Bid Bulletin #03

PROJECT: Weeping Water Public Schools
Additions & Renovations
Weeping Water, NE

RE: Addendum No. 2 to the Bidding Documents for:
Weeping Water Public Schools
Additions & Renovation
204 West O Street
Weeping Water, Nebraska 68463
Schemmer Project No. 06368.001

This addendum consists of nine 9 pages of written addendum items and thirty-three 33 pages of supplemental drawings.

SHEET NO: SDE-13

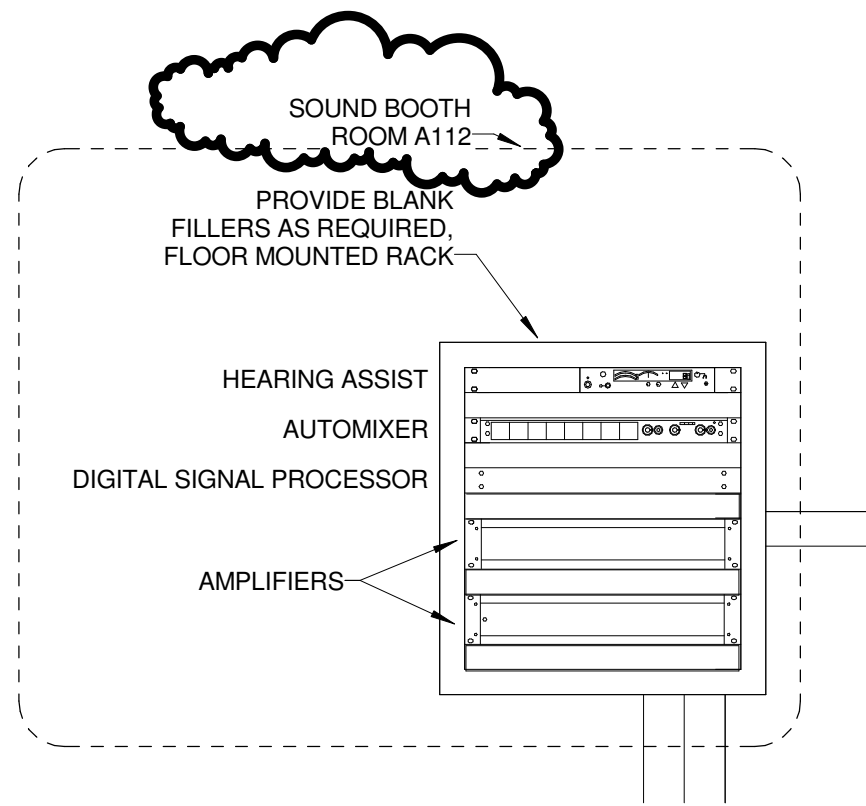
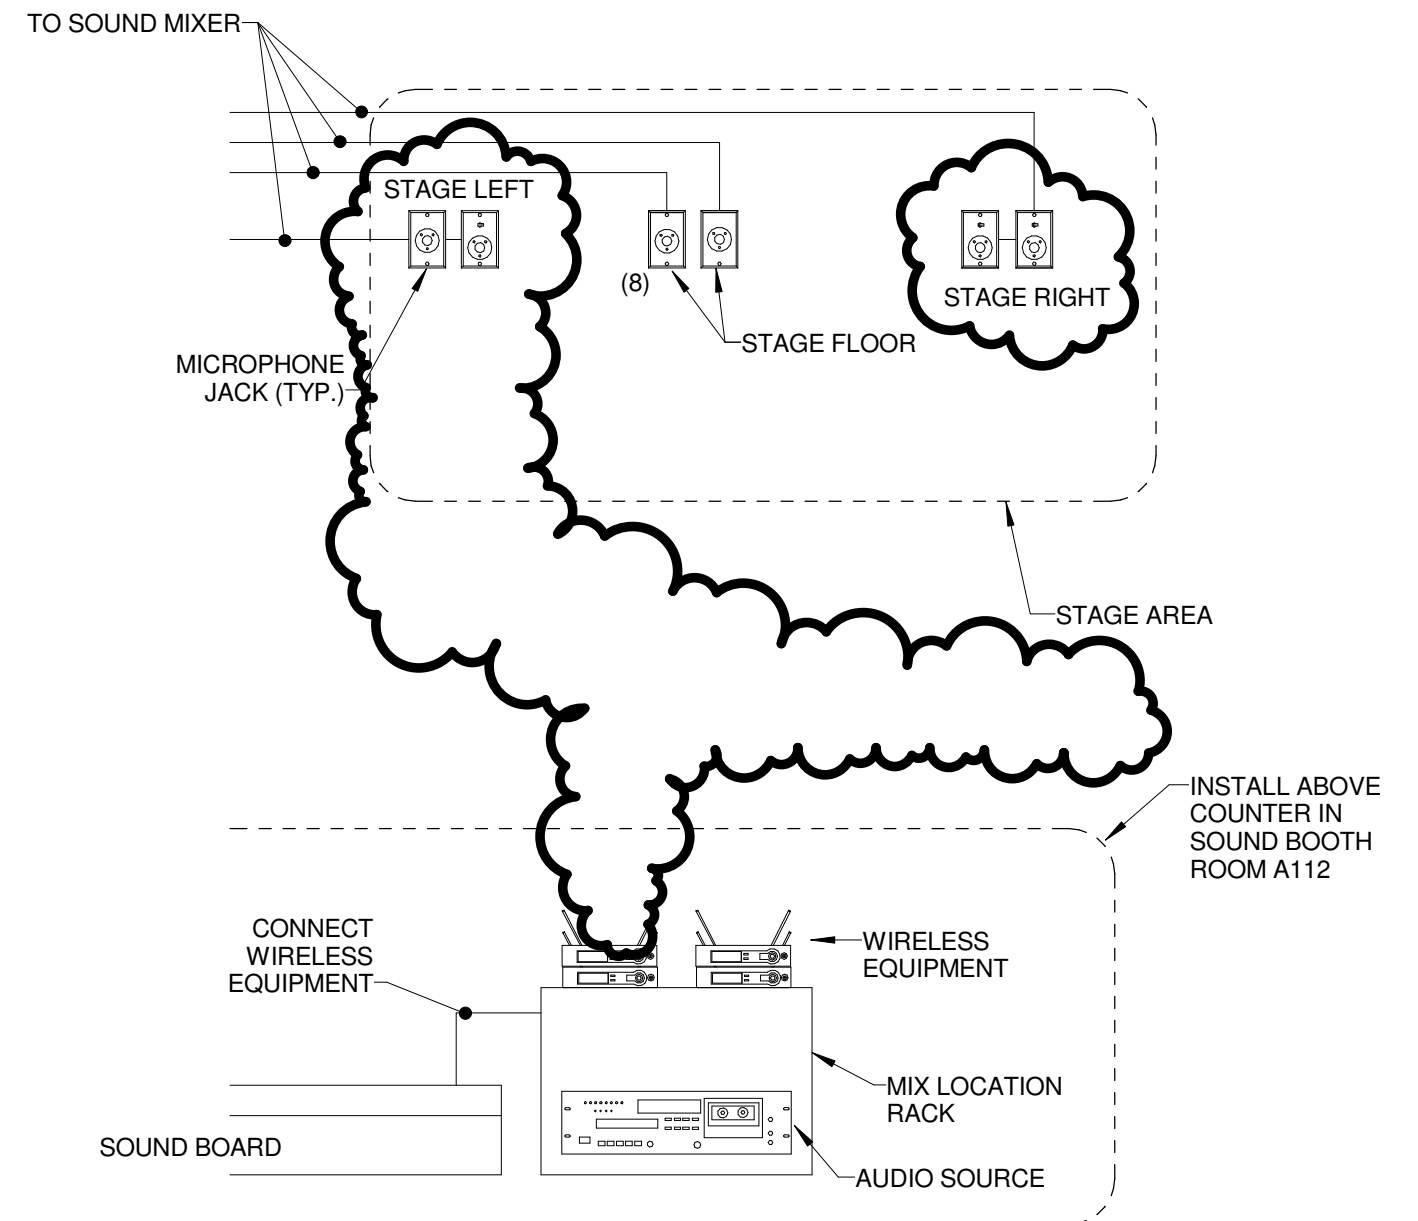
Item No. DE-6, Sheet E4-01.

- 1) See attached SDE-13 for electrical revisions.
- 2) See attached SDE-14 for electrical revisions.
- 3) See attached SDE-21 for electrical revisions.

SHEET NO: SDE-15

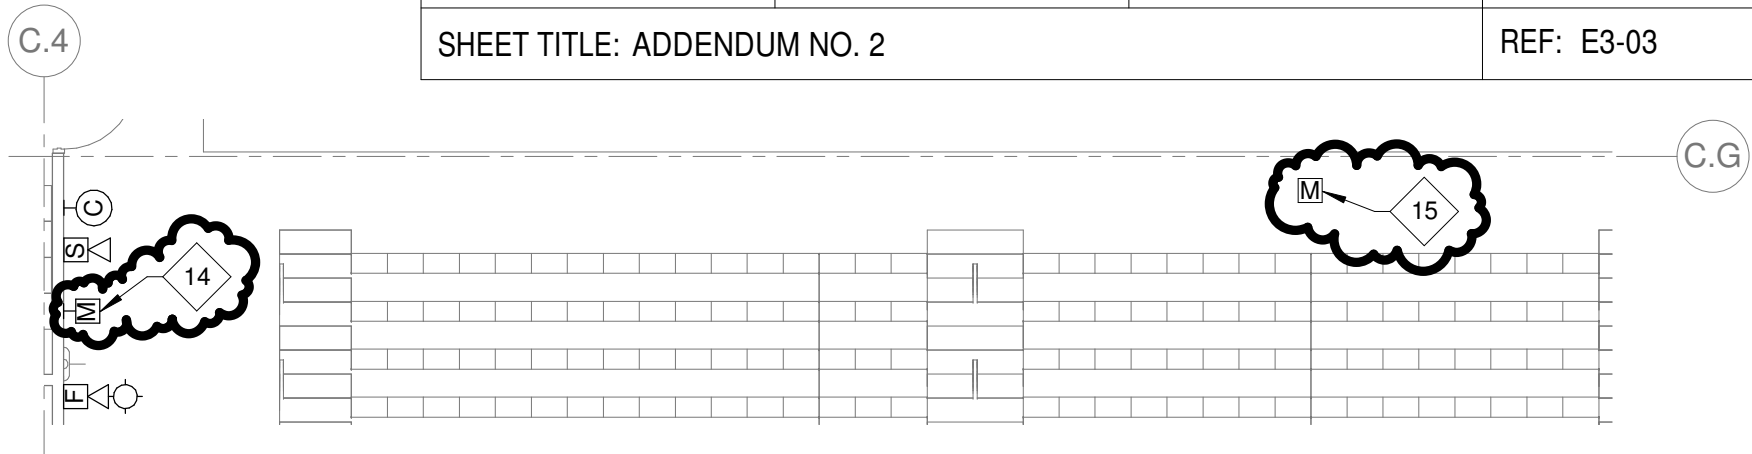
Item No. DE-3, Sheet E3-03.

- 1) See attached SDE-15 for electrical revisions.
- 2) See attached SDE-16 for electrical revisions.

SHEET NO: SDE-18

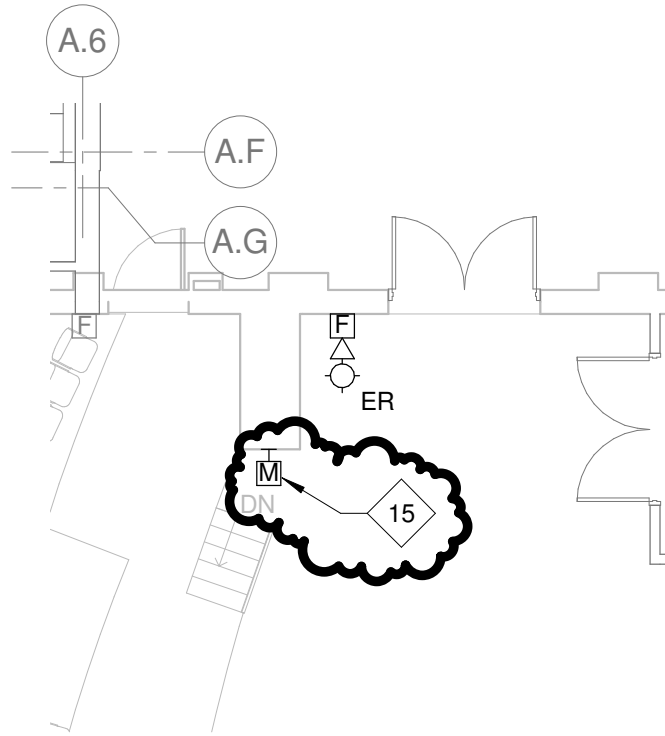
Item No. DE-4, Sheet E3-04.

- 1) See attached SDE-18 for electrical revisions.
- 2) See attached SDE-19 for electrical revisions.

SHEET NO: SDE-20

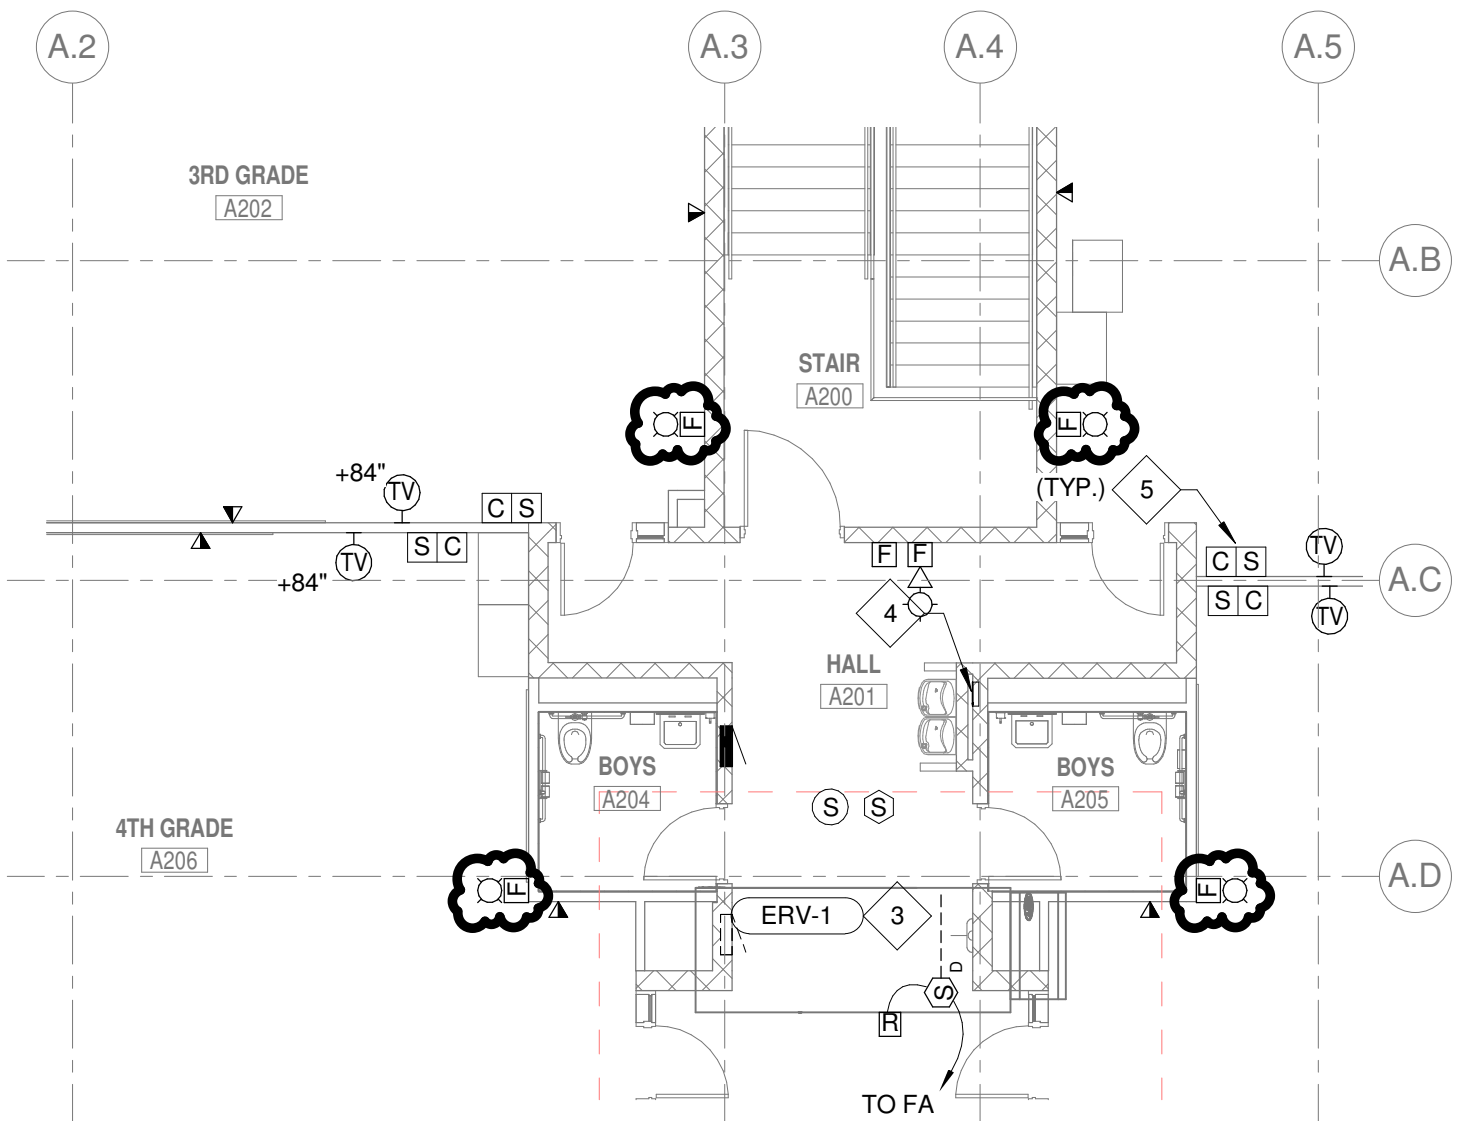
Item No. DE-5, Sheet E3-07.

- 1) See attached SDE-20 for electrical revisions.
